HISTORIC AND DESIGN REVIEW COMMISSION

HDRC CASE NO: 2023-397
ADDRESS: 410 PROBANDT ST
LEGAL DESCRIPTION: NCB A-14 BLK LOT N IRR 363.64 FT OF 19 PROBANDT SUBD
ZONING: IDZ-1, RIO-4
CITY COUNCIL DIST.: 5
APPLICANT: Luis Martinez/AREA Real Estate, LLC
OWNER: TEXAS ESSENTIAL HOUSING PUBLIC FACILITY CORPORATIO
TYPE OF WORK: Construction of a 4-story, multi-family residential structure, construction of accessory structures
APPLICATION RECEIVED: September 29, 2023
60-DAY REVIEW: November 28, 2023
CASE MANAGER: Edward Hall
REQUEST:

The applicant is requesting a Certificate of Appropriateness for approval to construct a 4-story, multi-family residential structure at 410 Probandt Street. The proposed new construction will feature 204 residential units and surface parking for approximately 270 automobiles.

WINDOW TYPES

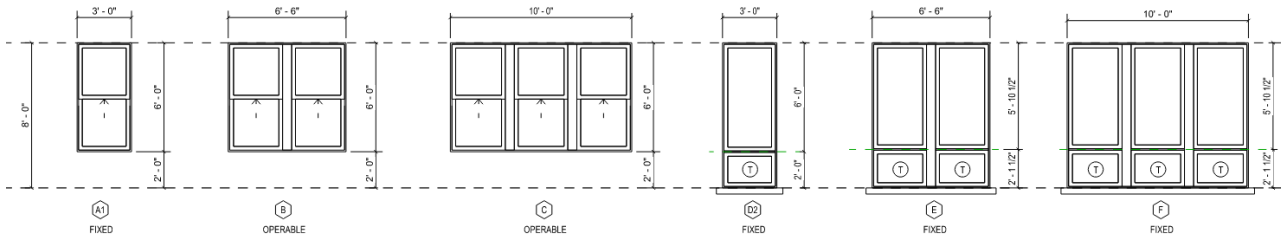
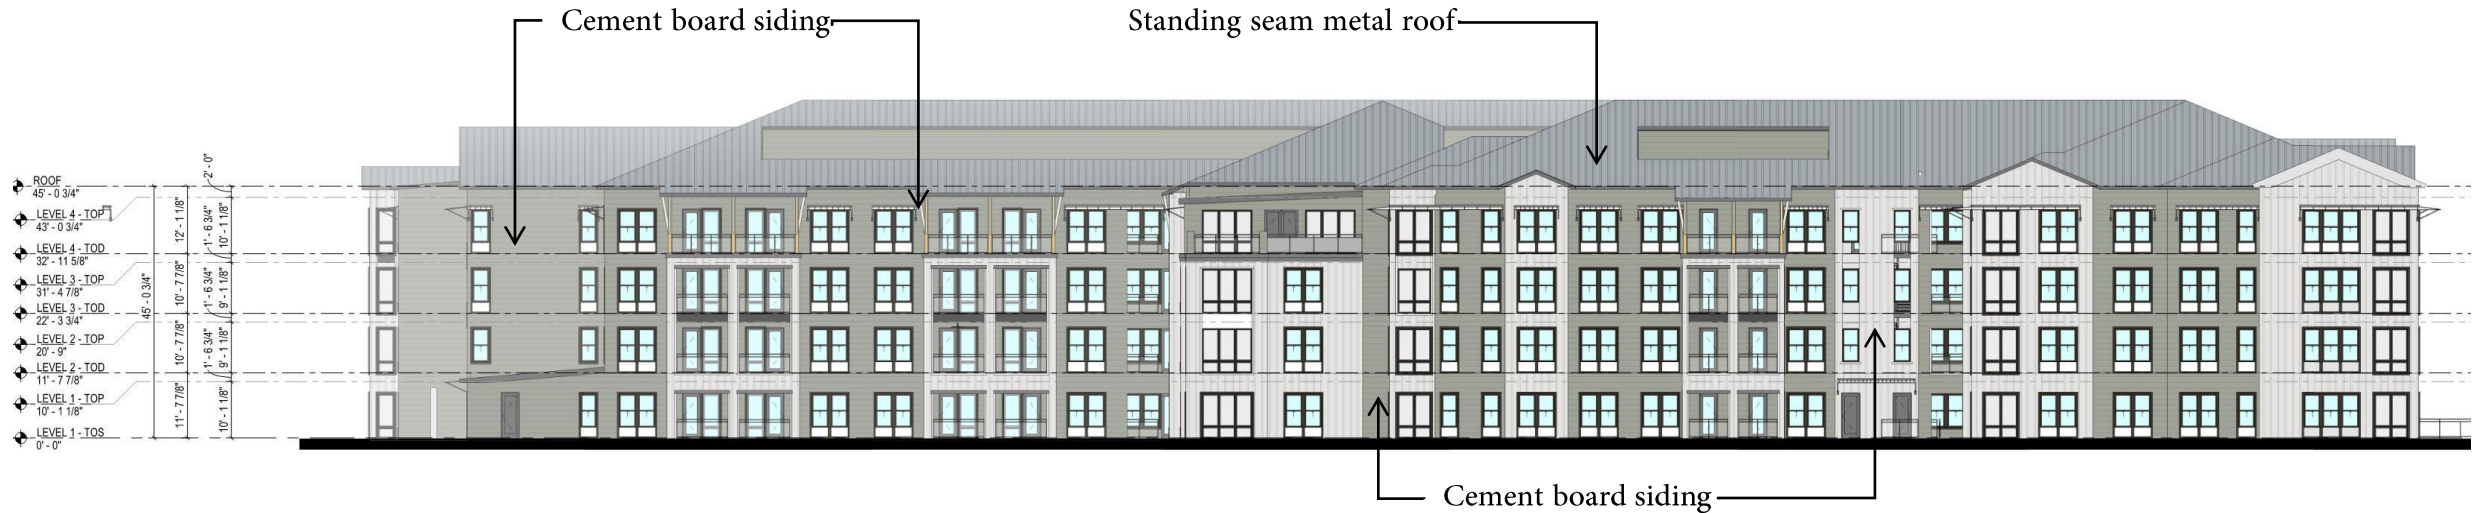
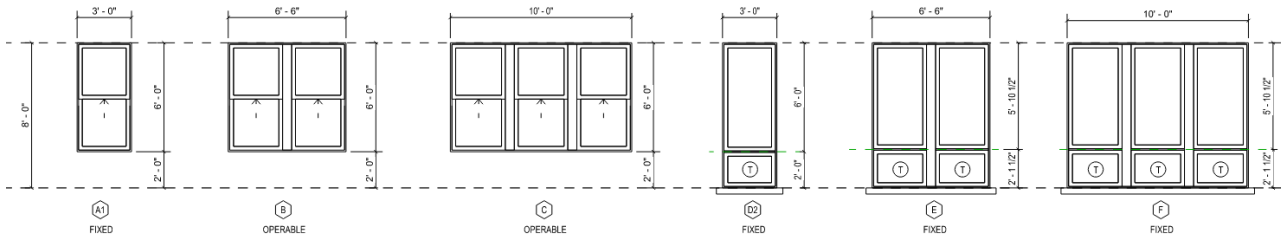
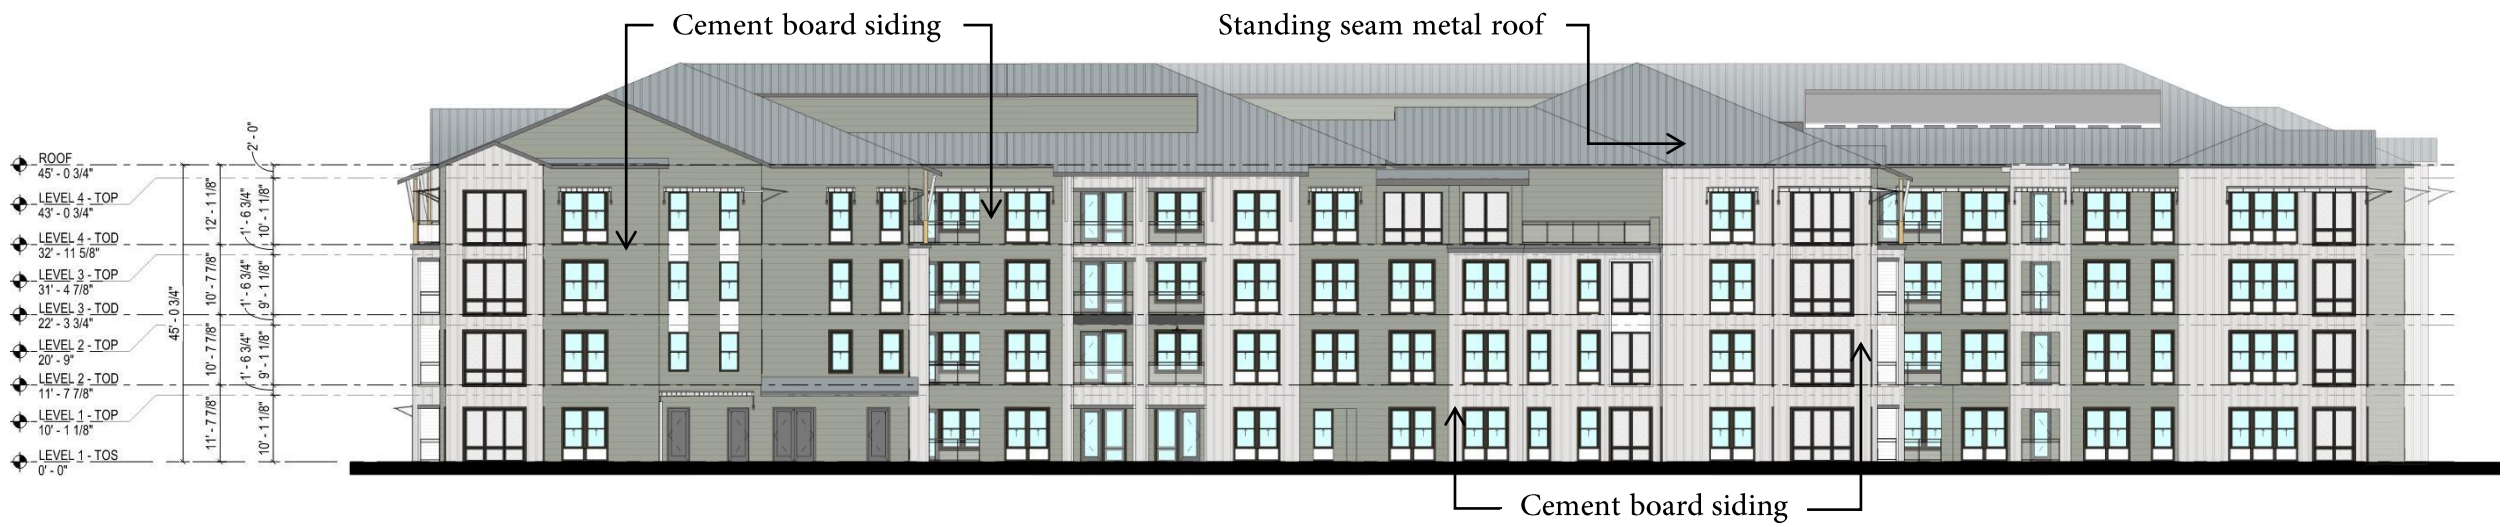
- m. **WINDOWS** – The applicant has proposed vinyl windows feature two primary profiles; one over one and fixed with unequally sized sashes. Generally, staff finds the proposed window profiles to be appropriate. The UDC Section 35-674(e)(A) notes that windows should be recessed at least two (2) inches within solid walls. The applicant is responsible for complying with this section of the UDC. Additionally, staff finds that all windows should feature dark colored frames.

- i. That all windows be recessed at least two (2) inches within solid walls and feature dark colored frames, as noted in finding m.
- ii. That the proposed standing seam metal roof feature panels that are 18 to 21 inches in width, seams that are 1 to 2 inches in height and standard galvalume finish.
- iii. That lap siding located on the primary structure feature a 4 to 6 inch exposure and a smooth finish.
- iv. That all outdoor furniture be consistent with the UDC, as noted in finding o.
- i. **ARCHAEOLOGY** – An archaeological investigation is required. The project shall comply with all federal, state, and local laws, rules, and regulations regarding archaeology, as applicable.
